IDAP REPORT

Property:	27A Kingsland Road Strathfield LOT 6 DP 28678 DA2022.74
Proposal:	Demolition of existing structures, construction of a dwelling with a basement and swimming pool.
Applicant:	A Nemra
Owner:	H Tamergi & N A Assi
Date of lodgement:	14 April 2022
Notification period:	25 April 2022 – 10 May 2022
Submissions received:	Nil
Assessment officer:	L Gibson
Estimated cost of works:	\$1,701,904.00
Zoning:	R2-Low Density Residential - SLEP 2012
Heritage:	No
Flood affected:	No
Is a Clause 4.6 Variation Proposed:	No
RECOMMENDATION OF OFFICER:	APPROVAL

Figure 3: Proposed Ground Floor Plan.

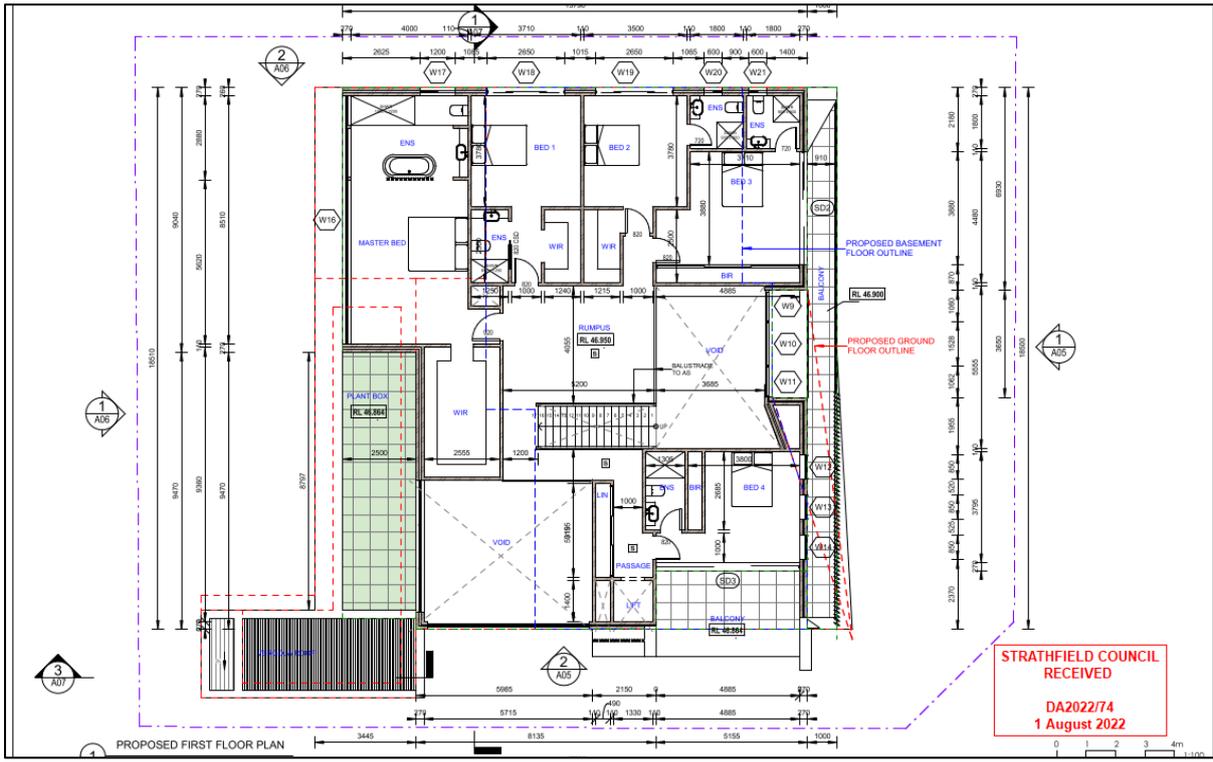
The proposal incorporates two voids located at the building's front entrance and over the proposed living area to the rear of the dwelling. Each void is proposed to a height of 6.2m which is contrary to the maximum 3m floor to ceiling heights required to be provided as per Section 4.2 of Part A of the SCDCP 2005. A floor to ceiling height of 2.9m is proposed to all remaining areas on ground floor and 2.85m to all remaining areas on the first floor which otherwise complies with this control.

The objectives of this control is to ensure that dwellings are compatible with the built form of the local area and that the overall bulk and scale, size and height of dwellings relative to natural ground level responds to adjoining dwellings, topography and desired future character. Whilst no concern is raised for the front entrance void as it is considered appropriate in size and provides added internal amenity to the dwelling, concern is raised for the rear void over the living area. The void is south facing adding little additional internal amenity for future residents. Further, the void contributes toward additional and unnecessary bulk, height and scale to the development which will be readily visible from its secondary frontage to Highgate

Street. This void is therefore not supported in this instance. A condition of consent is therefore recommended to ensure that the living room void be deleted and the floor to ceiling height be lowered to align with the remaining ground floor's 2.9m floor to ceiling height.

Amendments made in red on approved plans	All changes made in red on the approved plans shall be updated and shown on the Construction Certificate plans.
Living room void	Amended plans shall be prepared and submitted to PCA demonstrating that the living room void has been deleted and the floor to ceiling height lowered to a maximum height of 2.9m.
Front fence encroachment	No part of the front fence, including any footings or support work is permitted to encroach on Council's public footway.
Parapet Height	Amended plans shall be prepared and submitted to PCA demonstrating that the parapet wall shall be reduced from 1.2m to 800mm above the uppermost ceiling level.
Southern awning and toilet structures	Amended plans shall be prepared and submitted to PCA demonstrating that the southern awning has been deleted and for the toilet to remain as a standalone structure being raised no more than 3.5m above NGL so to comply with the maximum 3.5m building height for outbuildings as per Section 4.4.2 of Part A of the SCDCP 2005.

Figure 4: Proposed First Floor Plan.

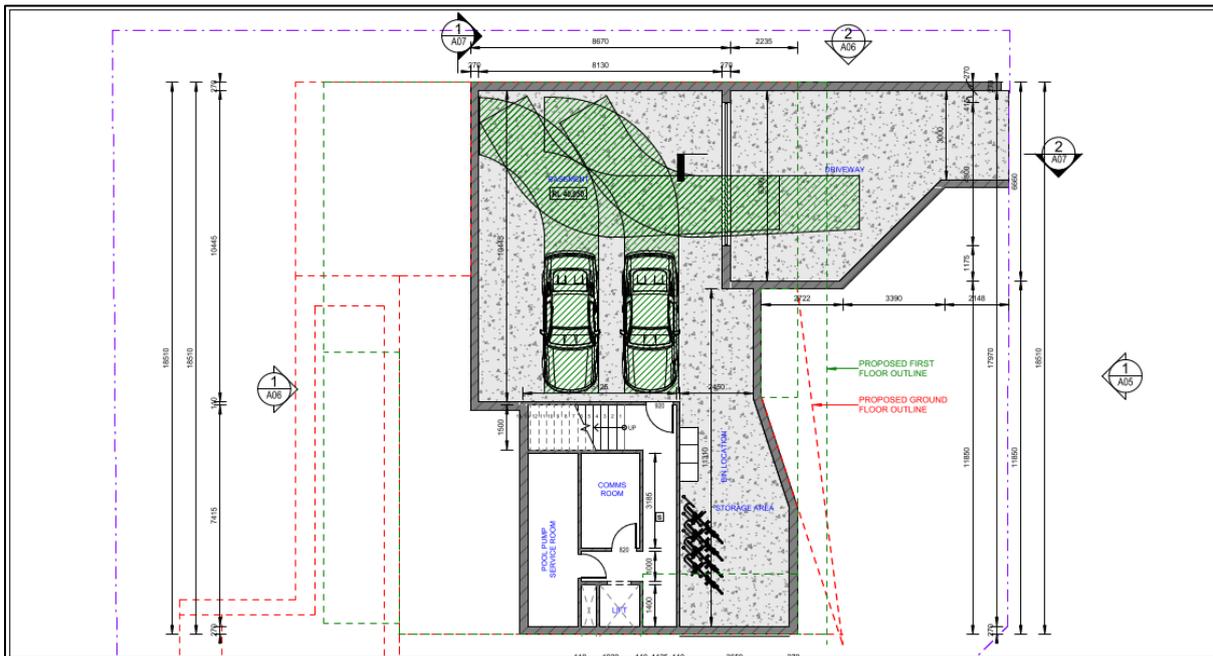
Section 4.2.3.2 of Part A of the SCDCP 2005 requires a minimum combined 4.76m (20%) to be achieved on the site. The proposal results in a combined setback of 3.3m - 5.153m which fails to comply with this requirement. The departure is a result of the proposed southern awning structure as well as the awning and blade wall structures proposed to the south facing balcony. Whilst it is appreciated that the angled blade walls to the south facing balcony are an expressive element providing visual interest and articulation to the façade, the structure is imposing on the street and will impinge view corridors and a sense of openness from being maintained within the streetscape. This is particularly noting that the balcony and awning face directly onto the secondary frontage and will be readily visible from the street. A condition of consent is therefore recommended for the south facing balcony's awning and supporting blade walls to be deleted so that the balcony and any supporting elements achieve a side setback of a minimum 3.4m from the site's southern side boundary.

South-facing balcony	Amended plans shall be prepared and submitted to PCA demonstrating that the south facing balcony's awning and supporting blade walls are deleted so that the balcony and any supporting elements achieve a side setback of a minimum 3.4m from the site's southern side boundary.

Figure 5: Proposed Basement Floor Plan.

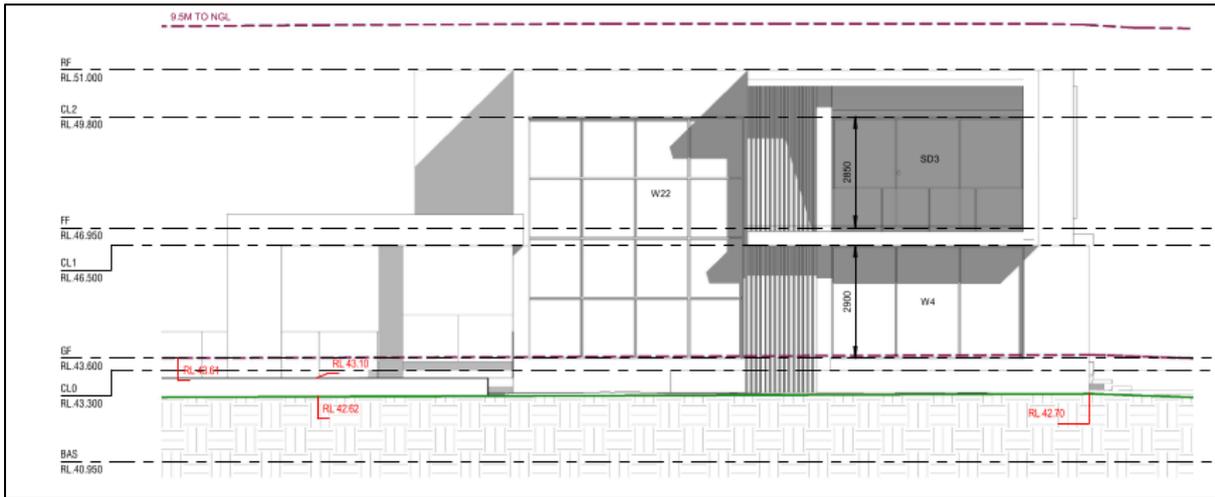
The basement carpark manoeuvring area and car parking dimensions indicated on plan No. A02 look to be satisfactory, allowing vehicles to enter and exit in a forward direction. This is considered satisfactory.
